Non-LOCA Methodology

SUBJECT: UNITED STATES - ADVANCED PRESSURIZED WATER REACTOR
FINAL TOPICAL REPORT SAFETY EVALUATION FOR TOPICAL
REPORT MUAP-7010-P, REVISION 4, "NON-LOCA METHODOLOGY"

The U.S. Nuclear Regulatory Commission (NRC) staff has prepared a proprietary and non-proprietary final Topical Report Safety Evaluation (TRSE) for Topical Report MUAP-07010-P, Revision 4, "Non-LOCA Methodology." This action is supported by letter dated April 29, 2013 (Agencywide Documents Access and Management System accession number ML13105A219), whereby the Advisory Committee on Reactor Safeguards agrees with the NRC staff's conclusions, within the limits and conditions that are specified in the TRSE. This is also in support of the United States - Advanced Pressurized Water Reactor design certification submitted by Mitsubishi Heavy Industries, Ltd. (MHI) on December 31, 2007.

Figure 3 SGTR Event - Break Flow

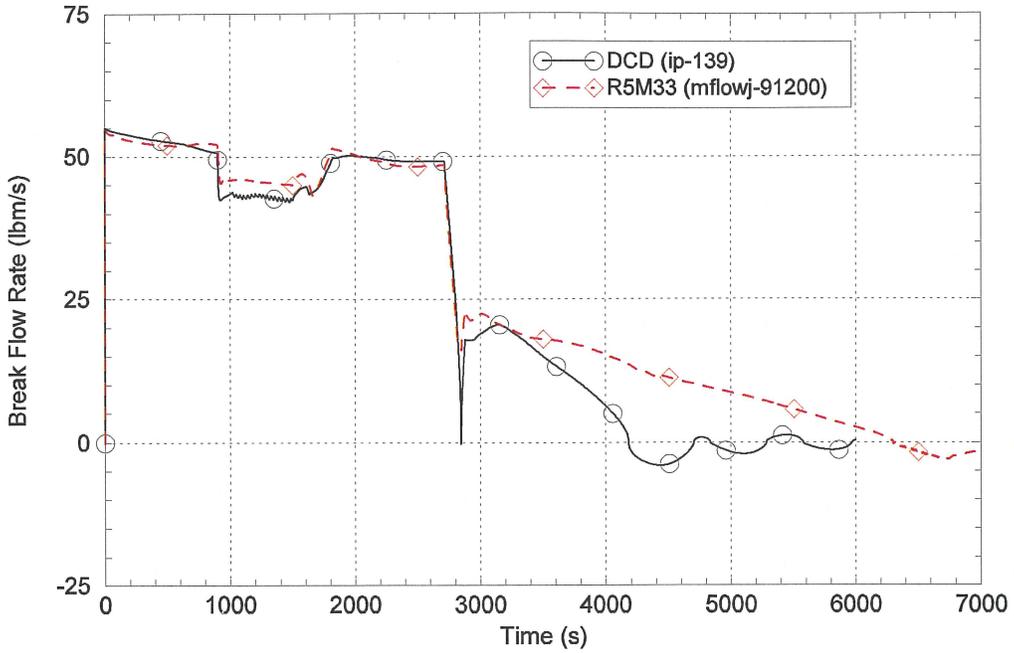
Thus, the goal of the confirmatory calculation was to see if MARVEL-M and RELAP5/MOD3.3 would give similar results when given the same initial and boundary conditions. Table 3 and Figure 3 through Figure 5 below show that the two codes provide similar results.

Figure 2.1-6 Steam Line Model

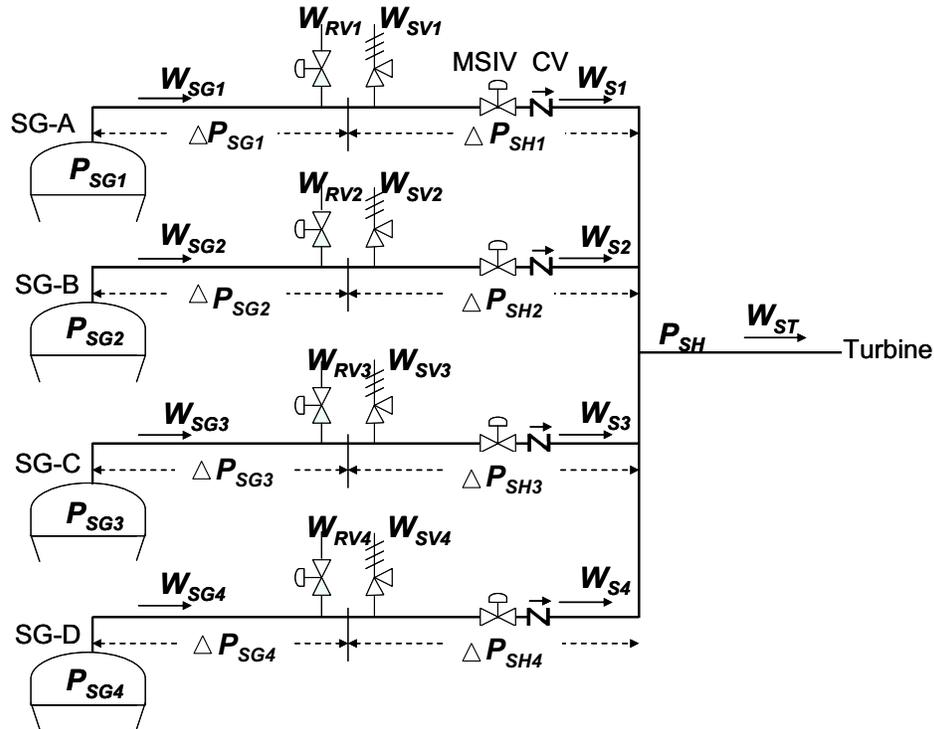
Topical report Section 2.1.3.4 describes the improvements of the MARVEL-M SG and secondary system model for expansion to four-loop capability. Figure 2.1-6, "Steam Line Model," shows the main steam lines from each SG are connected together at a common steam header, each via an isolation valve and a check valve. If the operating conditions of the SGs are different from each other, the steam outputs from the SGs are unbalanced. The steam flow distribution is then dependent upon the steam pressure of each SG and upon the pressure losses through the steam lines. A detailed description of the secondary steam generator model is provided in Section 1.8 of GEN0-LP-480. As described in Section A.8 of Appendix A of this report, the staff's evaluation of the secondary SG model and the method of evaluating the steam flow distribution found it acceptable.

Figure 2.2-1.1 Flowchart of the Discontinuity Factor Process

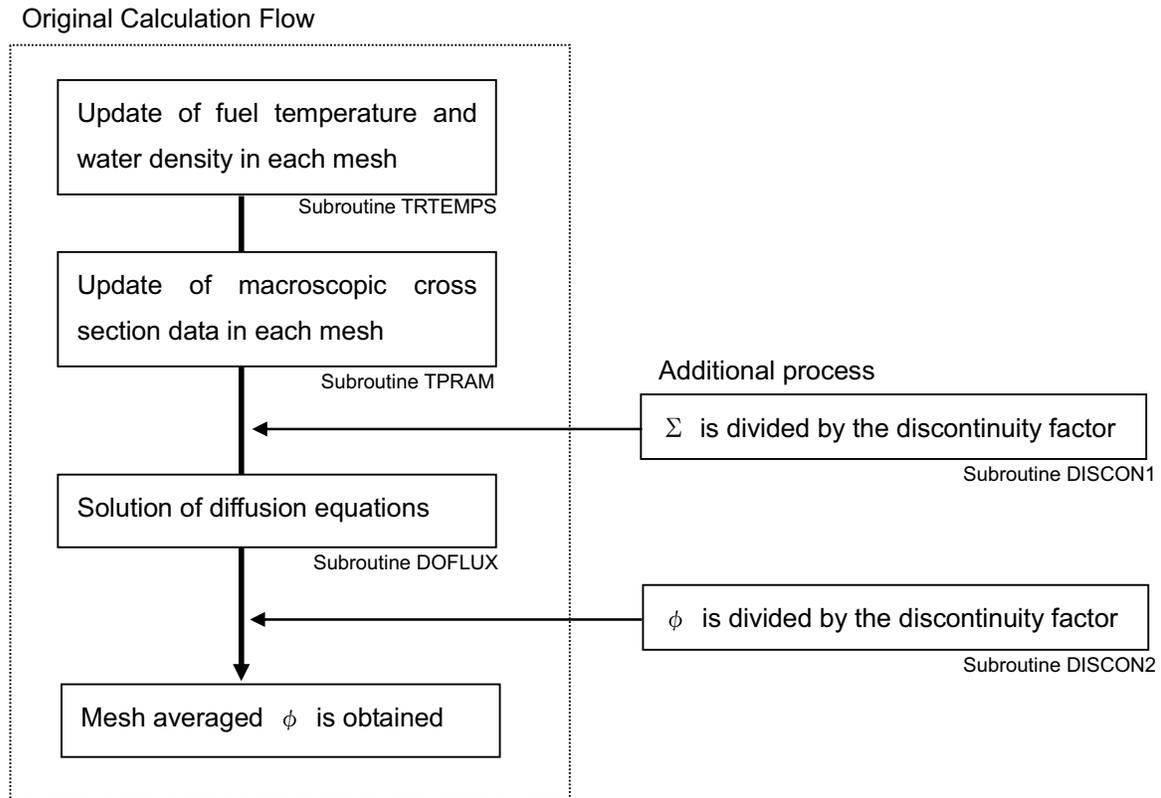
RAI 3.2-1 asked why the introduction of discontinuity factors was not considered a change to the constitutive models. The applicant presented a figure, Figure 2.2-1.1, "Flowchart of the Discontinuity Factor Process," in its response to RAI 2.2-1 [Ref. 19], showing that the addition of the discontinuity factor can be viewed as a pre-processing and post-processing activity outside the solution algorithm of the TWINKLE-M code and therefore does not represent a change to the constitutive model. The applicant's response is acceptable because it does not change the fundamental diffusion equations used by TWINKLE-M to solve for the neutron flux.
